Government of the District of Columbia

Department of Transportation

MEMORANDUM

SUBJECT: ZC Case No. 18-20 – The Yards Parcel I

Figure 1 – Site Plan (Source: CTR, Gorove/Slade, Figure 7, 11/26/18)

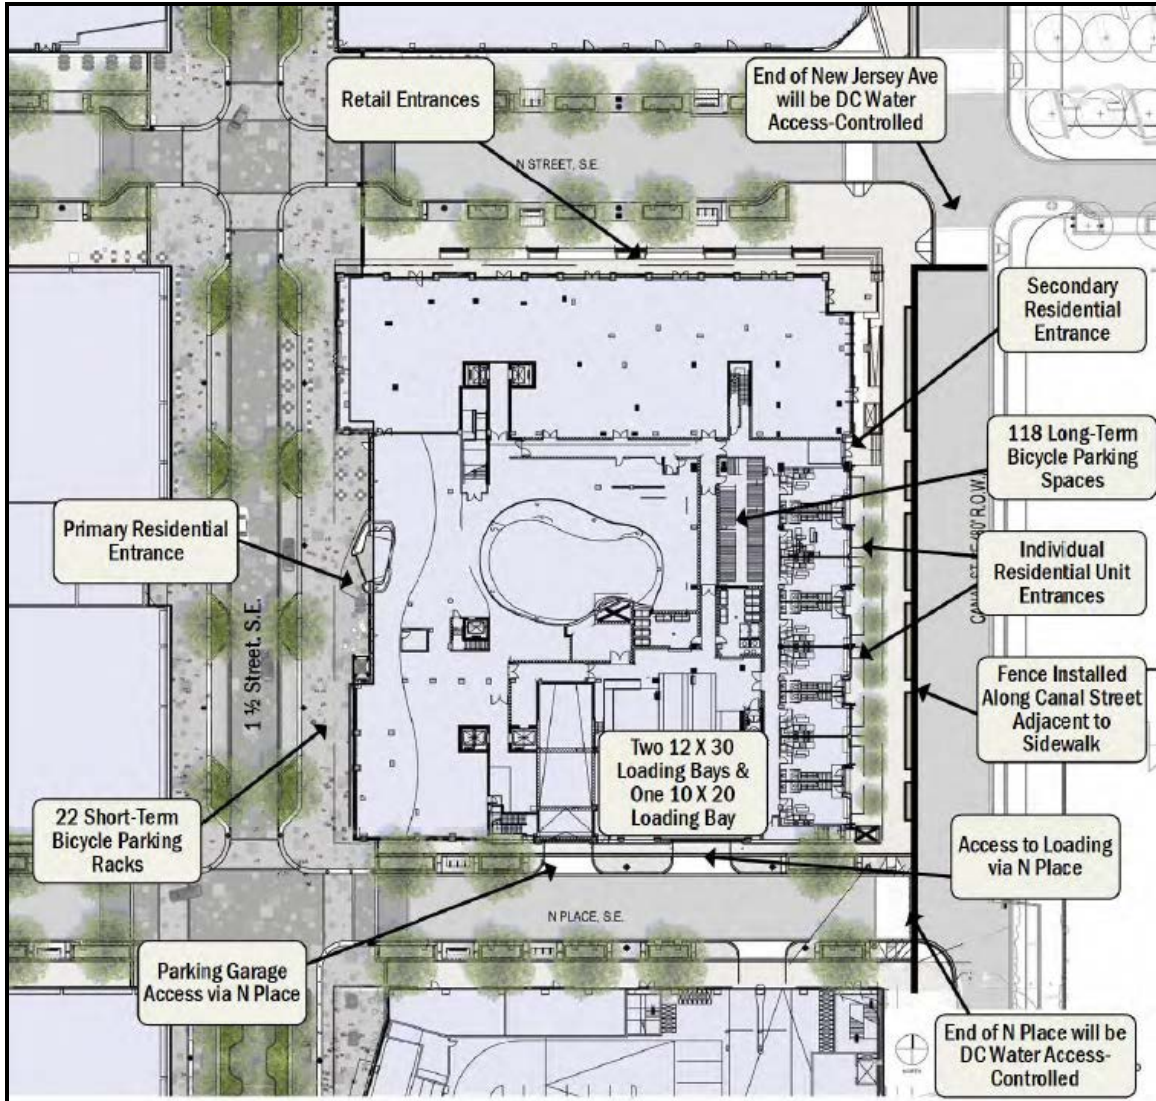
- Vehicular access to the parking garage and loading area will occur from two (2) curb cuts on N Place;
- The proposed two (2) 30-foot loading berths and one (1) 20-foot delivery space meets ZR16 loading requirements. However, it is not clear if the ZR16-required loading platforms are included with the berths. They should be shown on the plan set;

- The proposed 118 long- and 22 short-term bicycle parking spaces meet ZR16 requirements;
- It is not clear where the long-term bicycle storage rooms are located based on the October 12, 2018 plan set (Exhibit 2K). The plans should be revised to show the storage room(s) in easily accessible location(s) within the building or parking garage, as close to the ground floor as possible, and near the elevator or lobbies;

Subtitle C § 901.1 of the 2016 Zoning Regulations (ZR16) require two (2) 30-foot loading berths and one (1) 20-foot delivery space are required for the site. The Applicant is proposing to meet that requirement. However, it is not clear if the ZR16-required loading platforms will be provided. They should be shown on the plan set. The truck turning diagrams provided in the appendix of the November 26, 2018 CTR demonstrate that 30-foot trucks can enter the site head-in and exit head-out with all turning maneuvers made on private property, consistent with DDOT standards. The has proposed implementing a Loading Management Plan

- Maximize the number of street trees in public space, including adding one to the island between the two curb cuts on N Place;
- Maximize the amount of green space and minimize the amount of stairs, ramps, and pavement in public space on N Street;

- Update the planset to clearly identify the long-term bicycle parking storage rooms;
- Update the planset to show the inclusion of loading platforms attached to the loading berths;
- Implement the Loading Management Plan (LMP) as proposed in the November 26, 2018 CTR, for the life of the project, unless otherwise noted; and
- Implement the Transportation Demand Management (TDM) Plan, as proposed in the November 26, 2018 CTR, for the life of the project, unless otherwise noted, with the inclusion of a 23-dock Capital Bikeshare Station and the minor revisions requested by DDOT (see end of this report).

Figure 5 – Existing Pedestrian Infrastructure (Source: CTR, Gorove/Slade, Figure 29, 11/26/18)

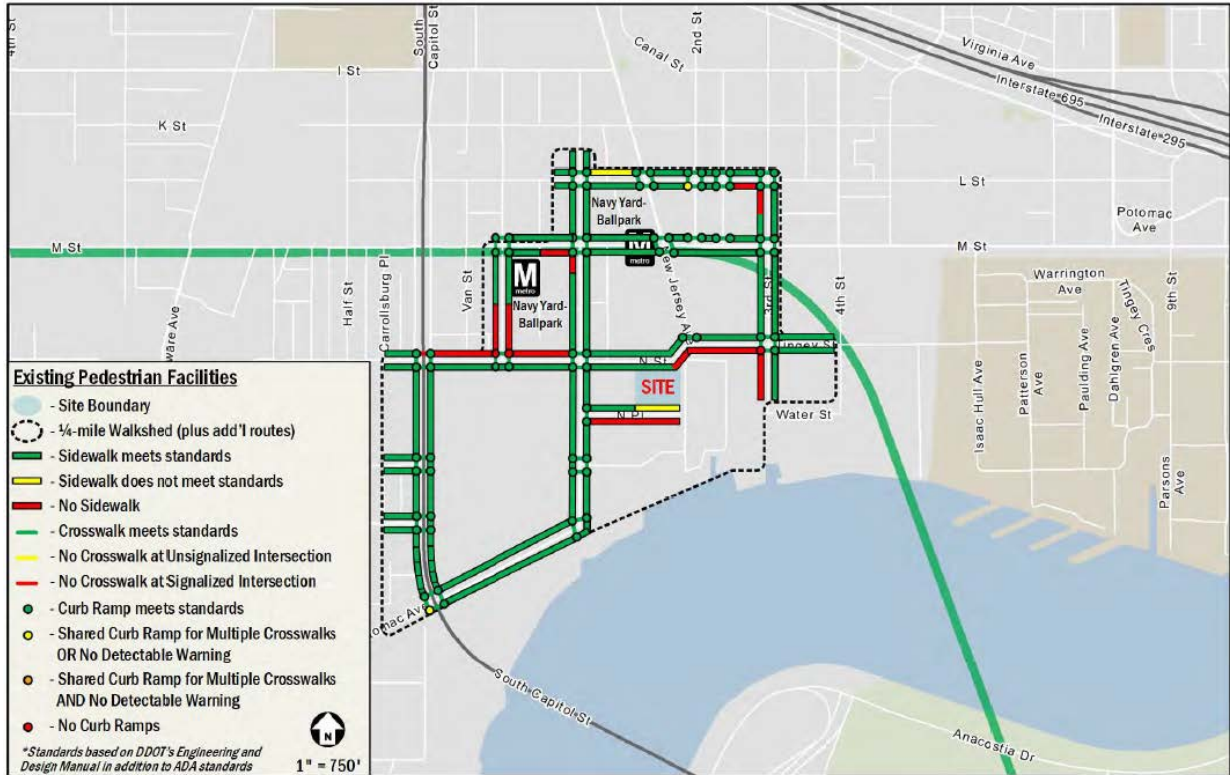
As shown above, there are a couple of missing or substandard sidewalk links in the immediate vicinity of the site, including several along N Place SE. As part of time extension approval for temporary surface parking lots on Parcels F, H, I, and Q (ZC 13-16A), the Applicant committed to the following proffer to construct the permanent sidewalk and public space design along the north side of N Place SE adjacent to Parcel H when Parcel I is developed, and vice versa, or by the end of 2019. DDOT notes that the segment of sidewalk along Parcel H is a critical connection between Parcel I, Nationals Park, and the Anacostia Riverwalk Trail.

1. *The Applicant shall commence construction of permanent sidewalk and public space improvements along the north side of N Place, S.E. between 1st Street and Canal Street by no later than December 31, 2019 unless it has commenced construction on Parcel H or I. If the Applicant has commenced construction on Parcels H or I, the Applicant shall commence construction of the permanent sidewalk and public space design for the entire length of N Place, S.E. on the north side prior to the issuance of a certificate of occupancy for Parcel H or I, whichever occurs first, or as otherwise governed by the zoning orders applicable to Parcel H or I.*
